PCN # ESW490-44 – Thyristor & Diode TO247_ISO247_PLUS247_ISOPLUS247 Packaging Location Transfer

Product/Process Change Notice (PCN)

PCN#: ESW490-44 **Date:** June 28th, 2022

Thyristor & Diode
TO247_ISO247_PLUS247_ISOPLUS247
Package Products

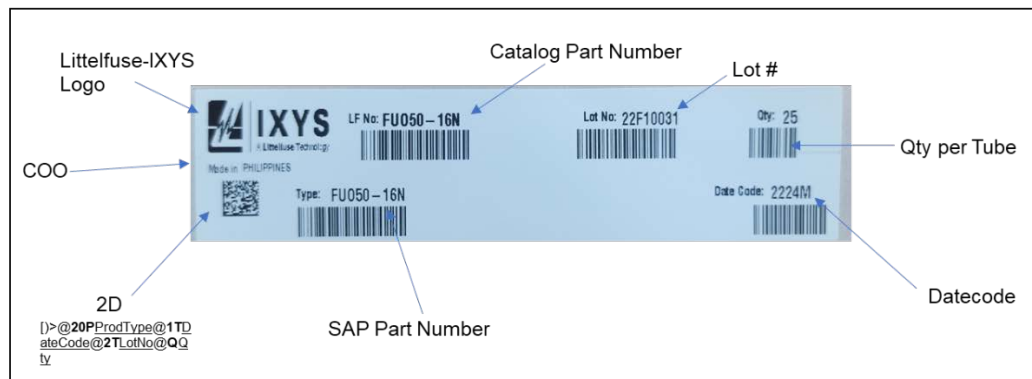
- 1) **Silicon Die:** No change
- 2) **Backend Assembly Bill of Materials:** No change
- 3) **Backend Assembly Process Flow:** No change
- 4) **Backend Assembly Equipment:** Equal or better
- 5) **Marking & Labeling:** Yes. Changes pls refer to below details.

DESCRIPTION	EXISTING LOCATION	SBU-LIPA	CHANGE (Y/N)	RISK	REMARKS
Unit Marking					
Logo			Y	LOW	Change to Littelfuse Logo
UL Sign	Yes	Yes	N	NR	No change
Trademark Sign	Yes	Yes	N	NR	No change
Product Name	Yes	Yes	N	NR	No change
Date Code	YYWW	YYWW	N	NR	No change
Assembly Line Code	L	M	Y	LOW	Site location code
Lot ID	FKT #	Lipa Lot ID format	Y	NR	SBU-Lipa uses global format
Box Label					
RoHS Label	e1 	e3 	Y	LOW	Both have printed RoHs compliance label
Logo			Y	NR	Change to Littelfuse Logo
Qty per Box	Yes	Yes	N	NR	No change
Part Number	Yes	Yes	N	NR	No change
Lot No	No	Yes	Y	LOW	Additional information from SBU-Lipa
Country of Origin	Yes	Yes	N	NR	No change
Code Type	Barcode	Barcode + 2D Code	Y	LOW	Additional scanning code to access information
Lot ID	FKT #	Lipa Lot ID format	Y	NR	SBU-Lipa uses global format
Date Code	Yes	Yes	N	NR	No change
Assy Line Code	L	M	Y	LOW	Site location code
Tube Label					
Logo			Y	NR	Change to Littelfuse Logo

Qty per tube	Yes	Yes	N	NR	No change
Part Number	Yes	Yes	N	NR	No change
Lot No	No	Yes	Y	LOW	Additional information from SBU-Lipa
Country of Origin	Yes	Yes	N	NR	No change
Code Type	Barcode	Barcode + 2D Code	Y	LOW	Additional scanning code to access information
Lot ID	FKT #	Lipa Lot ID format	Y	NR	SBU-Lipa uses global format
Date Code	Yes	Yes	N	NR	No change
Assy Line Code	L	M	Y	LOW	Site location code
